RFI

RFI #: 125
 Date: 5/21/2012
 Job: EB-02 Keller Springs Lofts
 Phone: 877-777-5115

CC:
 Subject: A1 and A1-HC Unit Questions

Drawing: A2.2 & A2.2HC
 Cost Impact: None

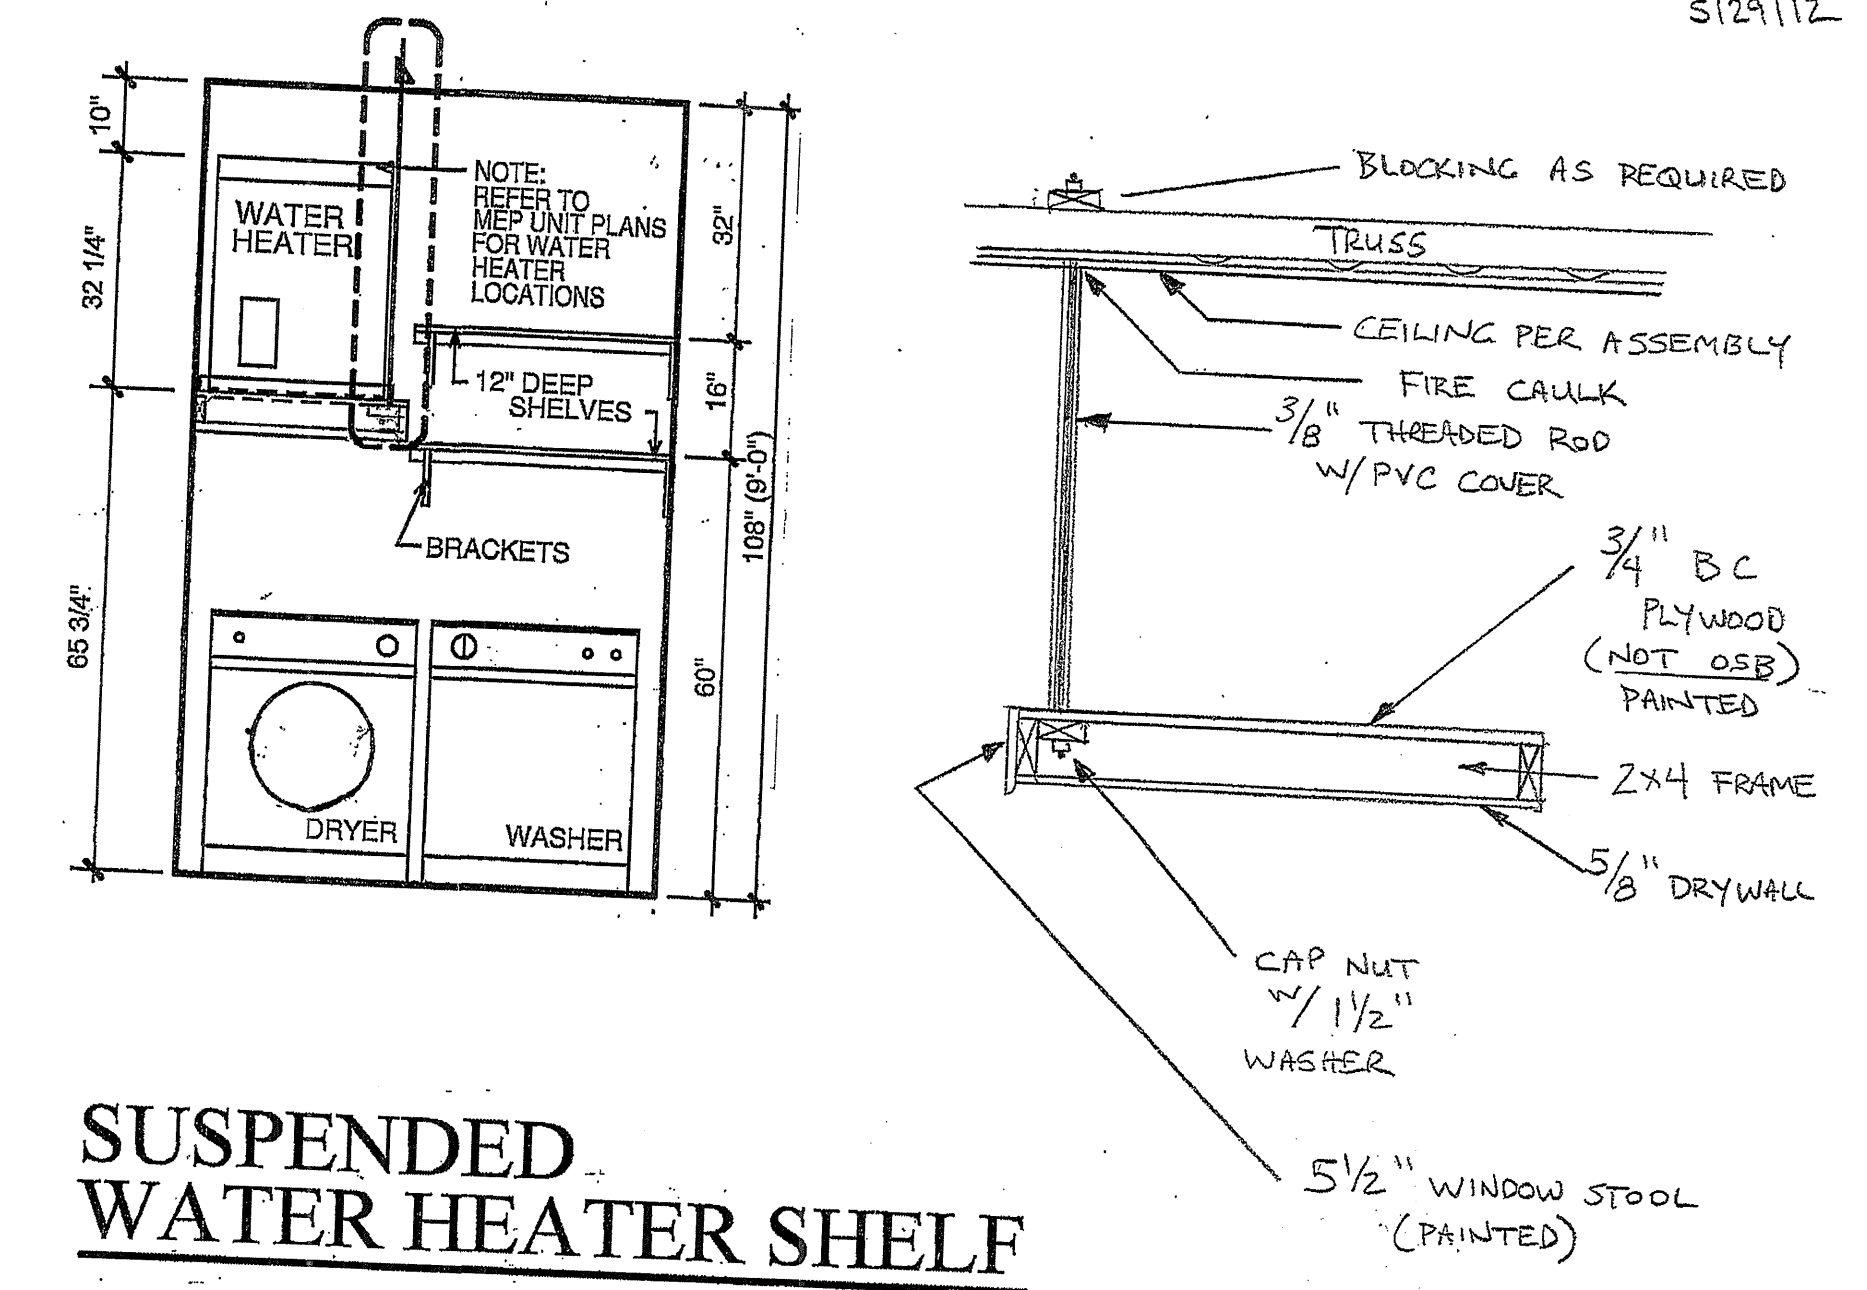
Request: Date Required: 5/29/2012
 A1 Unit - Please provide length of wall dimension for wall that separates vanity and toilet.
 A1HC Unit - Please provide door number for bathroom door from the kitchen area. Also provide dimensions for where the door sits.

Response: The wall in the A1 unit is 2'-1".
 The door tag in A1HC is 10.
 Off the plumbing wall where the tub is, the wall is 4" for the door frame, the door is 3'-0", then there is 2'-0" till the wall where the closet door is.
 The dimension text that is on top of the door tag says 5'-4".
